Commonwealth Edison
One First National Plaza, Chicago, Illinois
Address Reply to: Post Office Box 767
Chicago, Illinois 60690

February 20, 1981

Subject: LaSalle County Station Units 1 and 2
Resolution of Safety Evaluation Report Issues
NRC Docket Nos. 50-373/374

In response to questions from the NRC Staff, information is provided herein to resolve remaining issues in the LaSalle County Safety Evaluation Report. The areas addressed are the following:

LASALLE SECOND LEVEL UNDERVOLTAGE PROTECTIONS
 IE-1-4000 PJ
 4/3/80 RAS.

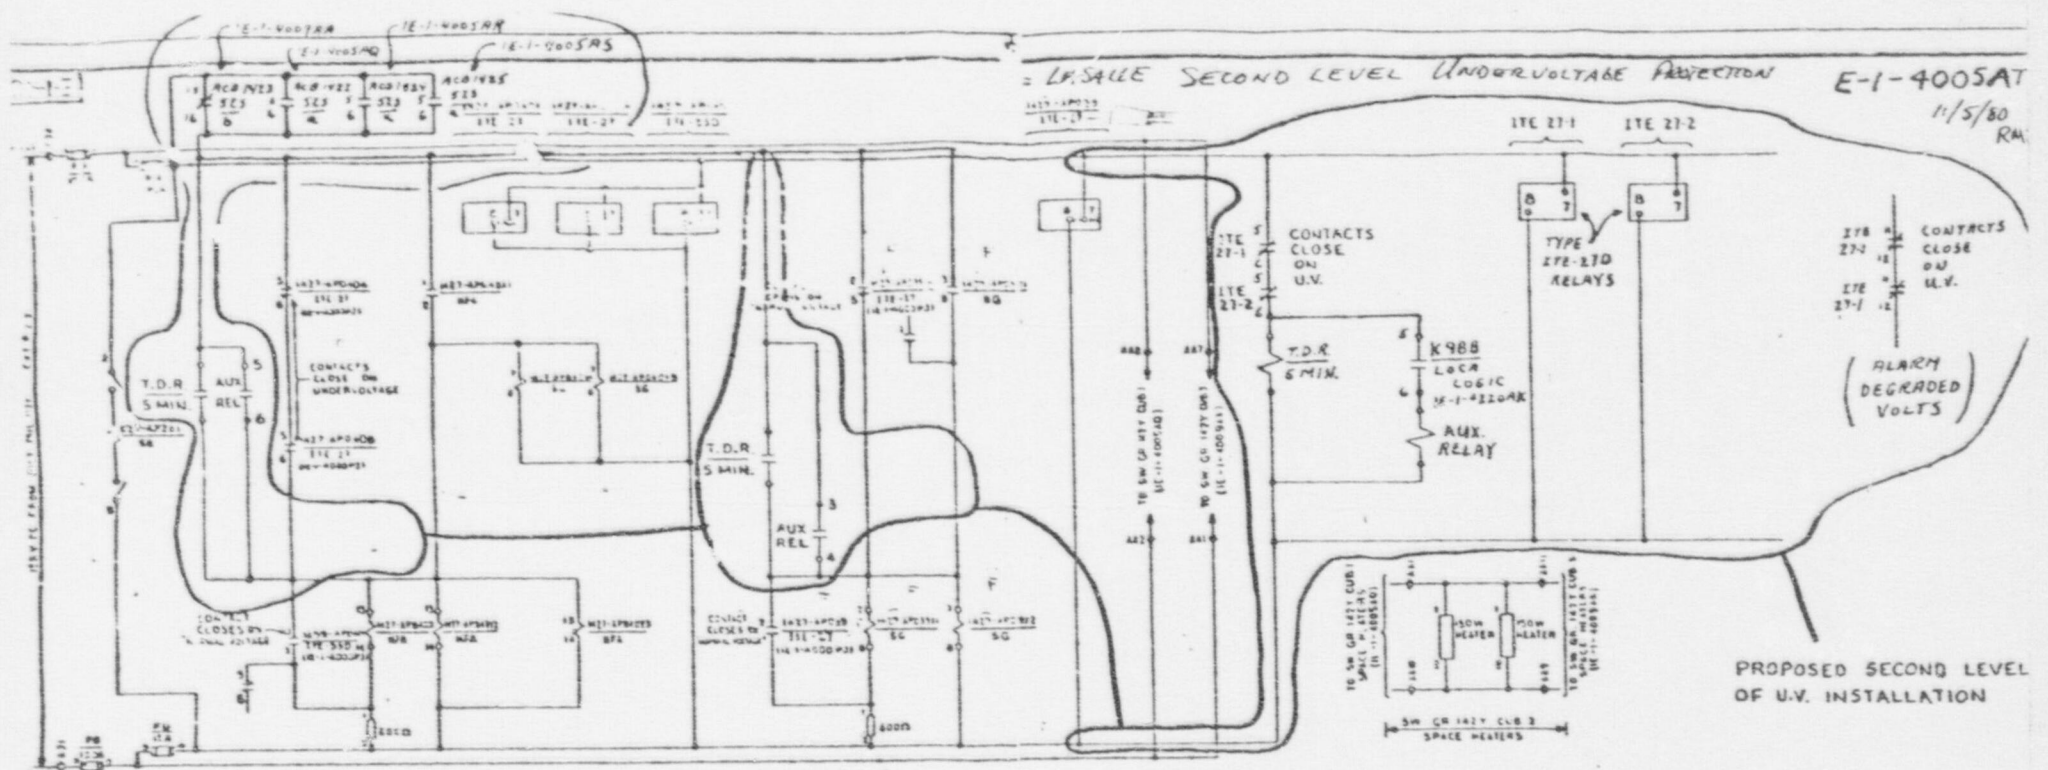
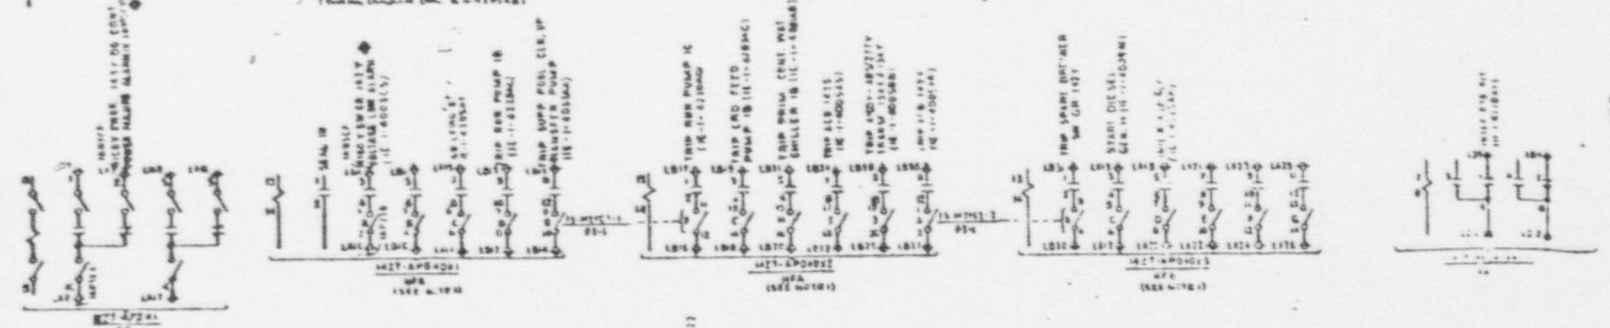
The primary undervoltage protection design for LaSalle County is documented in the FSAR and has been reviewed by the NRC Staff. Attached are schematics of the second level of protection. As was previously indicated in LOD 81-40-14, the ITE-27-1 relays have built in item delay setpoint which will be set at 10 seconds. These drawings will be incorporated into the FSAR Section 1.7 upon verification by the Staff of its acceptance of the design.

LA SALLE COUNTY STATION
FINAL SAFETY ANALYSIS REPORT
FIGURE Q40.106-1
TEST CELL ARRANGEMENT

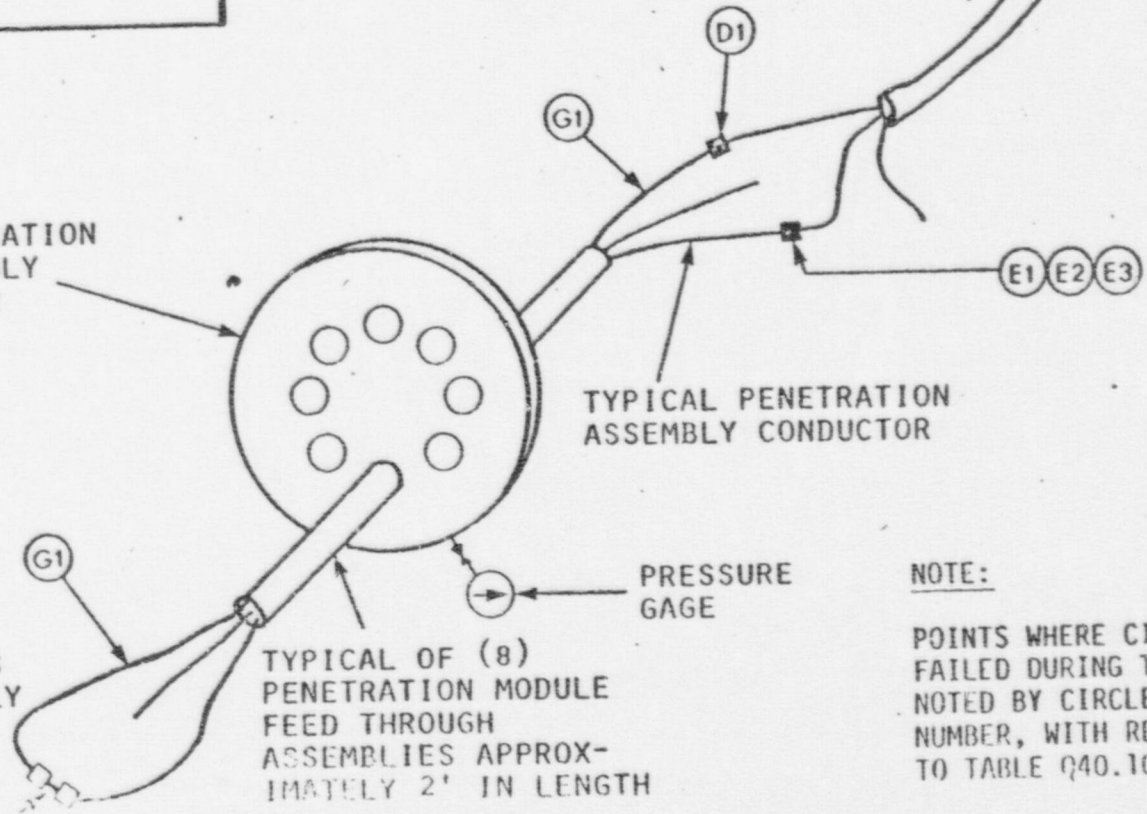
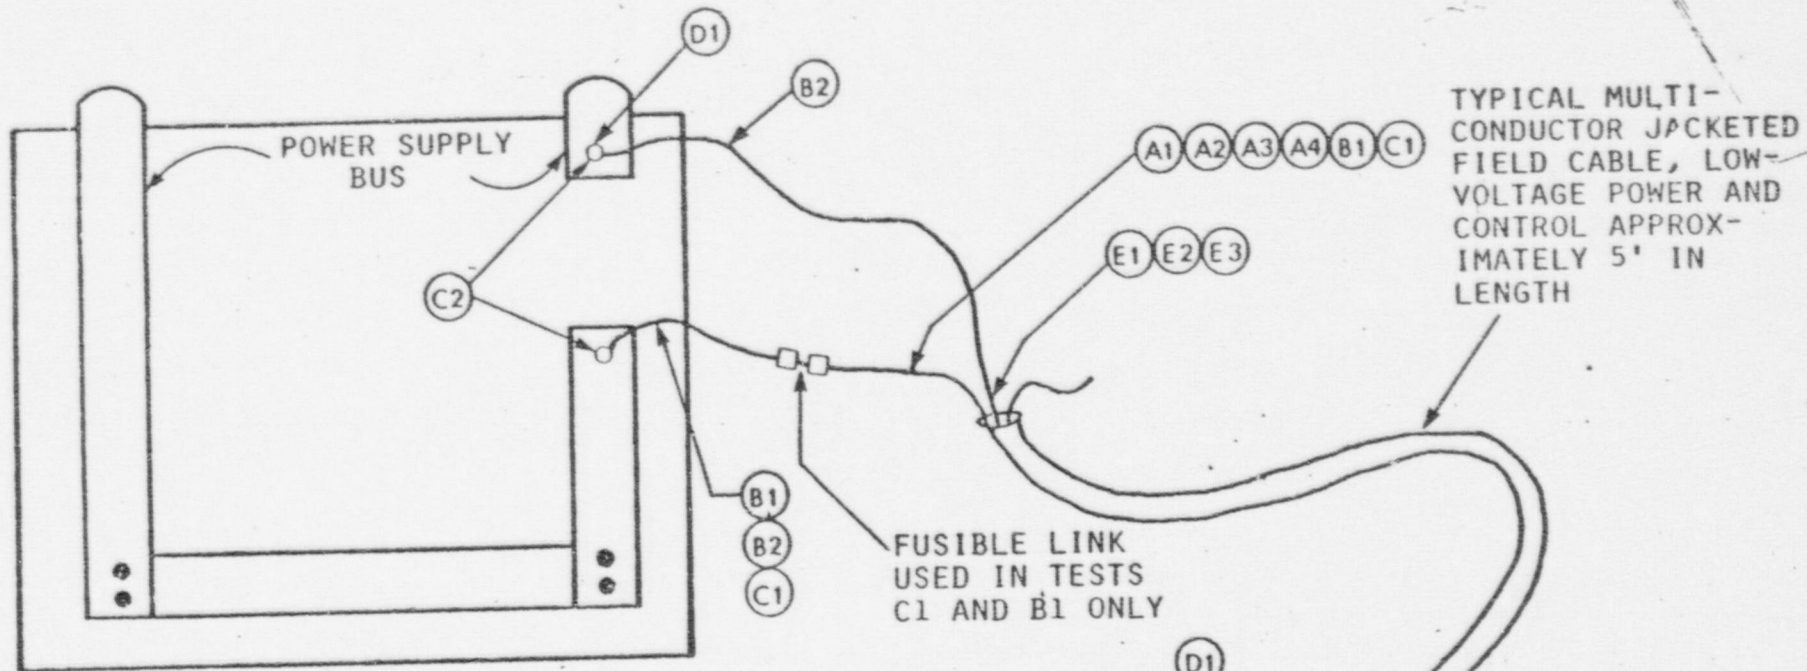
** Reference Figure Q40.106-1 for Test Arrangement

(2) and (3) Tests, which were conducted at the Gould/ITE High Power Testing Laboratory in Chalfont, Penn. on February 28, 1978, demonstrated for the field cable/penetration combinations tested that the La Salle County Station design is valid without exception, provided that the penetration assembly conductors are at least one standard (AWG) size larger than the connected field cable. The failure (fusing) of the field cabling with resulting interruption of the test occurred before any damage occurred to the penetration assembly or pressure seal integrity. This was true for all cases where the relative size of cable followed the qualification combinations used at La Salle. Figure Q40.106-1 and Tables Q40.106-2, Q40.106-3, and Q40.106-4 describe the tests and results. The last column to the right in Table Q40.106-4 shows that for configurations identical to LSCS field/penetration cable interface sizings, the maximum thermal capacity of the penetration conductors is from approximately ~~198%~~ 239% to approximately ~~40%~~ 440% of the thermal load experienced during testing. Hence sufficient margin exists between the penetration conductor's maximum thermal capacity and the thermal load to field fusion for all the required LSCS field/penetration cable interface sizings.

6.9KV SWGR LOAD
 (THIS FIGURE IS REPRESENTATIVE FOR BOTH
 OF THE 6700V SWGR LOADS)

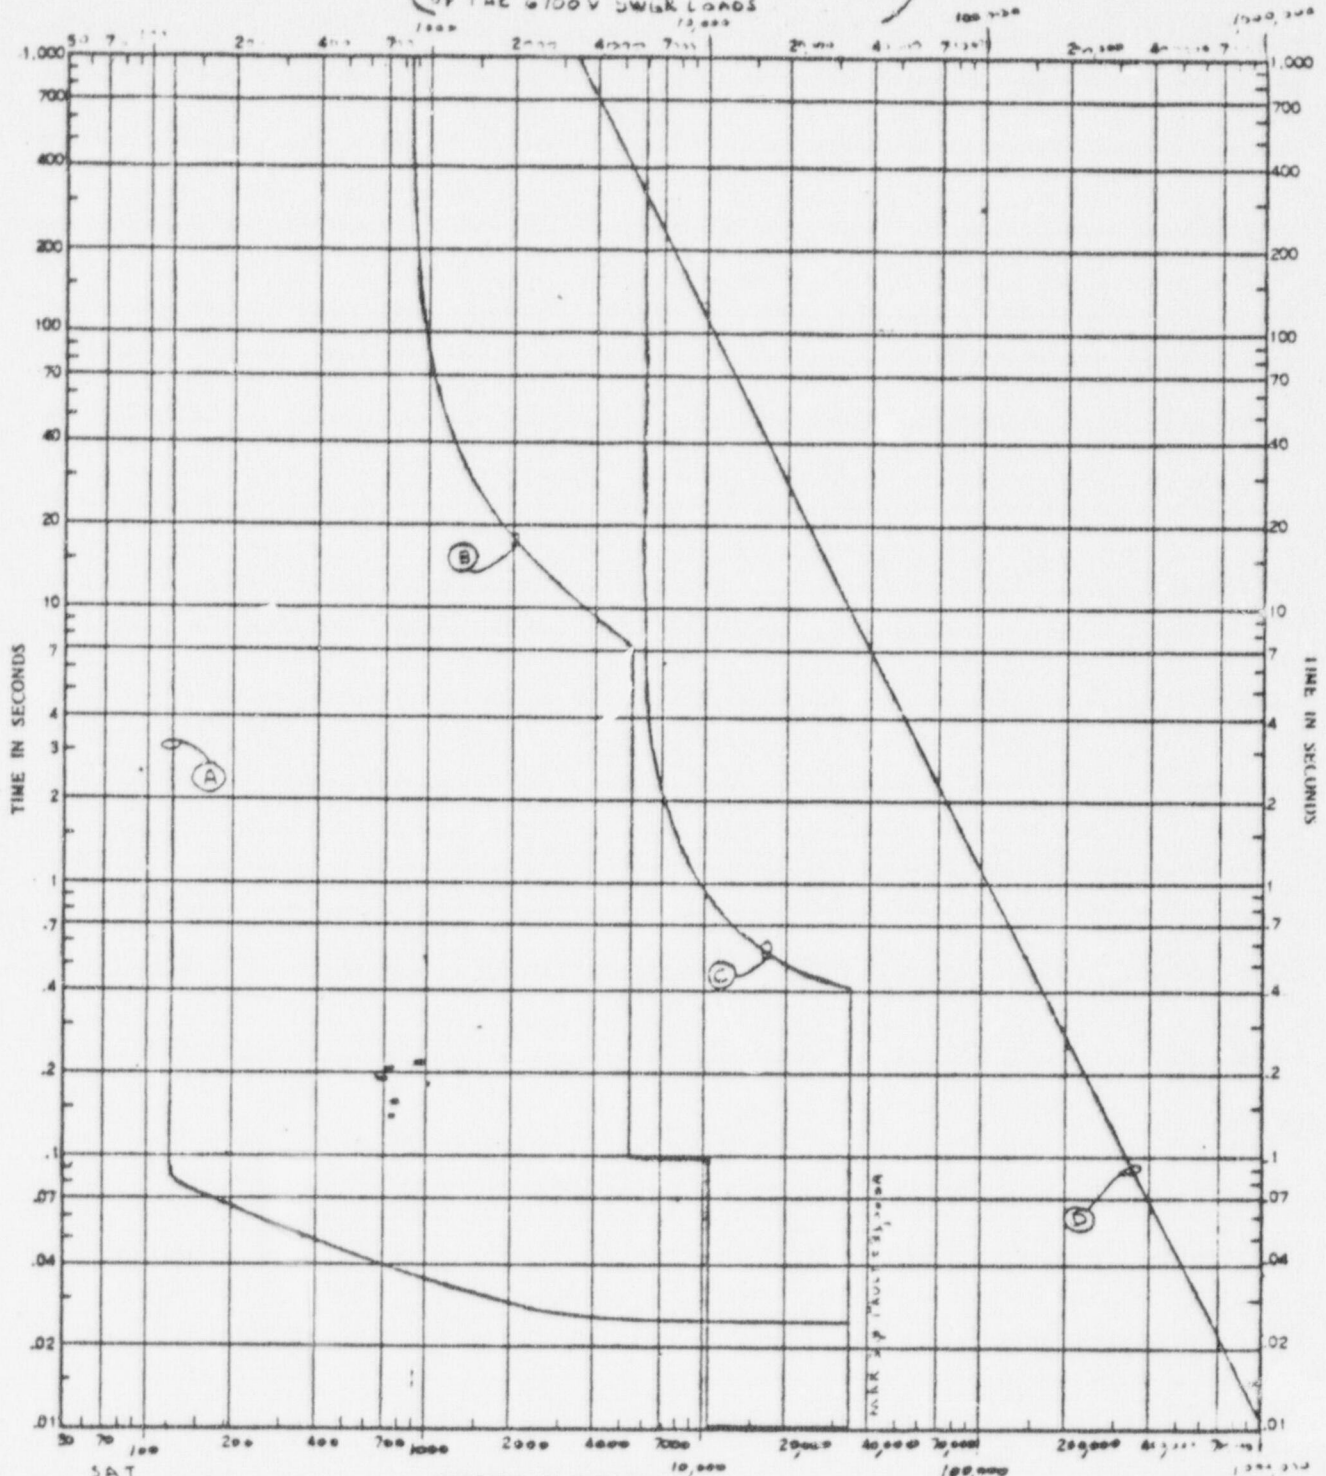
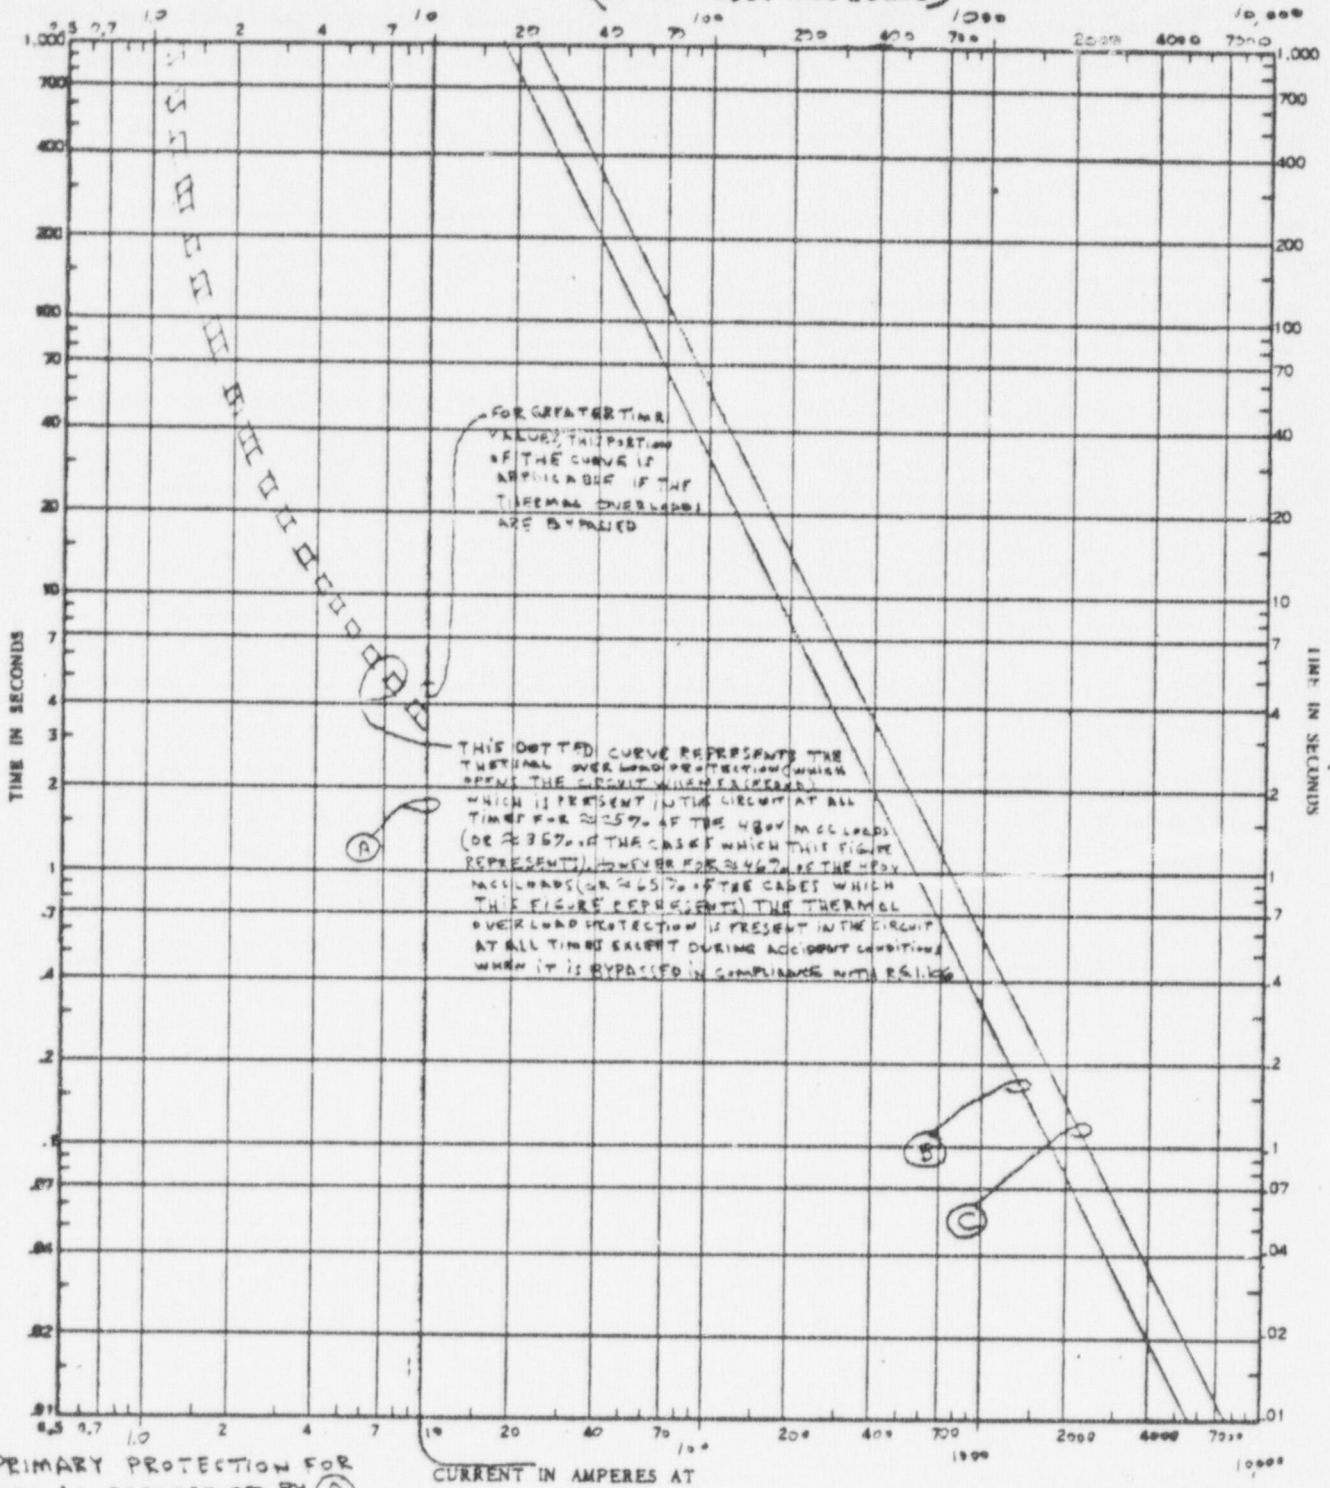
- (1) The response states that the electrical penetrations for the La Salle County Stations are designed with oversized conductors through the penetration seals such that they can withstand any conceivable fault current versus time condition not interrupted by the primary protective device. Provide a quantified meaning for the terms 'any conceivable fault current' for the 6900, 4160 and 480 volt electrical penetrations. Also quantify the maximum time duration for which this conceivable fault current is to be applied to each of the above three types of electrical penetrations.

design does not take advantage of the oversized penetration conductor but rather has primary and backup ^{fault current} protection for the ELECTRICAL penetration assembly (EPA) as shown in Figure Q40.106-2. Coordination curves showing the primary and backup ^{fault current} protection for the low voltage penetrations are provided in Figures Q40.106-3, Q40.106-4, Q40.106-5, Q40.106-6 and Q40.106-7.

THE PRIMARY PROTECTION FOR THE EPA IS REPRESENTED BY (A). NOTE THAT (A) IS FOR HIGHLY SENSITIVE DIFFERENTIAL RELAYING WHICH TRIPS BREAKER (A) AT BUS 151-1 FOR THE INDICATED DIFFERENTIAL CURRENT VALUED BETWEEN THE RRP AND MOTOR NEUTRAL CONNECTION LOCATED AT THE MOTOR AND BUS 151-1.

THE BACKUP PROTECTION FOR THE EPA IS REPRESENTED BY (B). NOTE THAT (B) IS FOR OVERCURRENT RELAYING WHICH TRIPS BREAKER (B) AT BUS 151. ALSO NOTE THAT SIGNIFICANT BACKUP PROTECTION IS ALSO PROVIDED BY (C). (C) IS FOR OVERCURRENT RELAYING WHICH TRIPS BREAKER (C) AT BUS 151.

FIGURE Q40.106-4
 FAULT CURRENT PROTECTION
 FOR LOW VOLTAGE PENETRATIONS

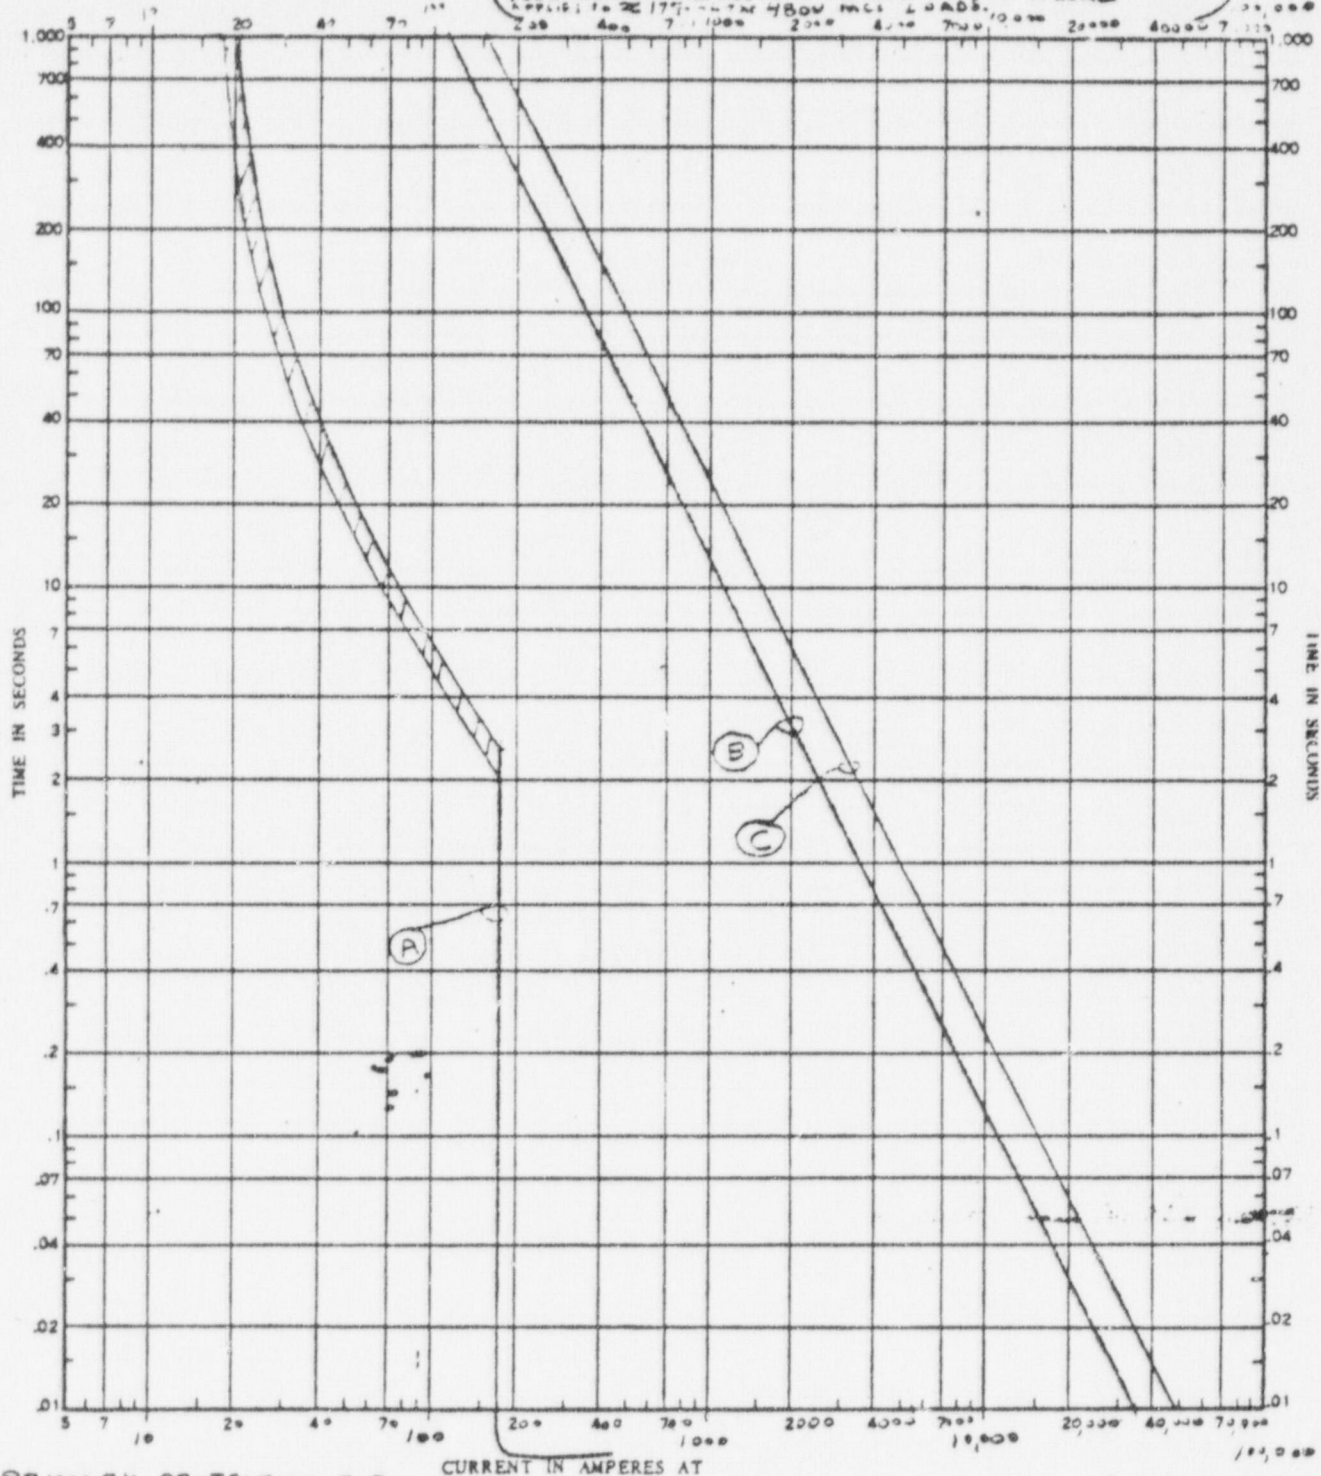
Also, Figures Q40.106-3, Q40.106-4, Q40.106-5, Q40.106-6 and Q40.106-7 illustrate that ample margin exists between the backup fault current protection and the conservative thermal limit capability curve of the electrical penetration.
